UNITED STATES PATENT AND TRADEMARK OFFICE

APPLICATION NO.	FILING DATE	FIRST NAMED INVENTOR	ATTORNEY DOCKET NO.	CONFIRMATION NO.
10/517,141	12/07/2004	Masao Nagano	59406.00026	6837

Office Action Summary

DETAILED ACTION

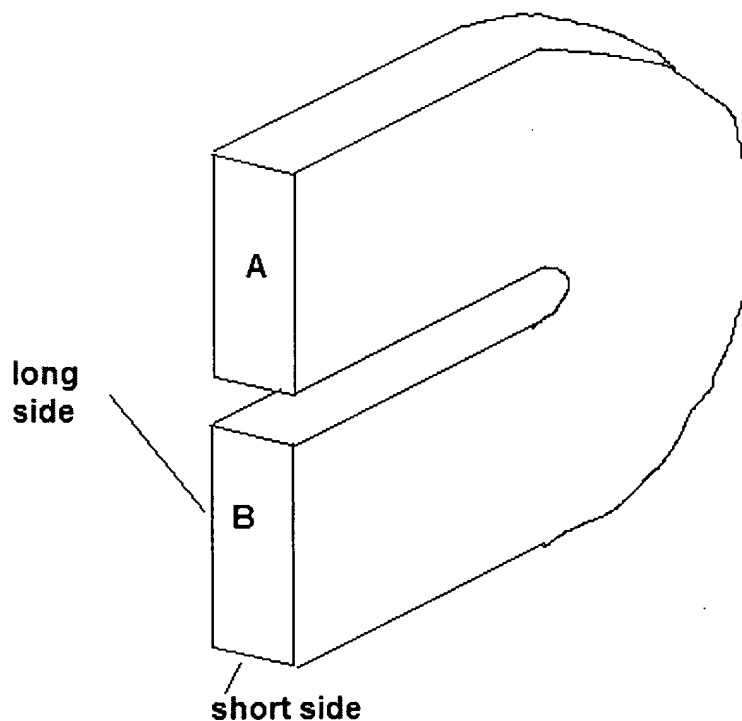
Ozawa discloses a slotless permanent magnet rotary electric machinery (see Fig. 1), comprising:

- a substantially cylindrical rotor (7, Figs. 1 and 2) incorporated with a permanent magnet (1, Fig. 2),
- a stator iron core (1, Fig. 1) surrounding the rotor; and

- a coil (15, Figs. 1 and 2) provided between the rotor and stator core in a spaced relationship with respect to the rotor, characterized by that:
 - the coil comprises a plurality of turns which are shifted from one turn to another along the circumferential direction in a mutually overlapping manner (see Fig. 3); and

- the coil turns are formed by a conductor (27, Fig. 6) having an elongated cross section, a long axis (side having 6 conductors 25 in Fig. 6) of the cross section extending in a radial direction (see Figs. 3-9; see note below),

- wherein the conductor is provided with a rectangular cross section (see Fig. 6) having a long side (6 conductors 25 in Fig. 6) and short side (3 conductors 25 in Fig. 6), and the long side extends in a radial direction (see note below; see Figs. 3-9) and wherein the rectangular cross section of the conductor is rounded at the four

corners thereof; individual conductors 25 are rounded (col. 9, para. [0060]), and therefore the composite conductor 27 has rounded corners as well.

Note: To easily visualize this, compare Figs. 3, 5, and 6. From Fig. 3, it is clear that the U-shaped end turns 37 are such that when the coil is rolled into a cylinder, one leg of the U will be farther out radially than the second leg of the U. From figs 5 and 6 it is clear that each leg of the U (when viewed as the letter U) is wider than the thickness of the letter itself, i.e. as in the figure below. It is clear then that conductor A is at a radially outward position of the cylindrical coil, and B is at a position radially inward.
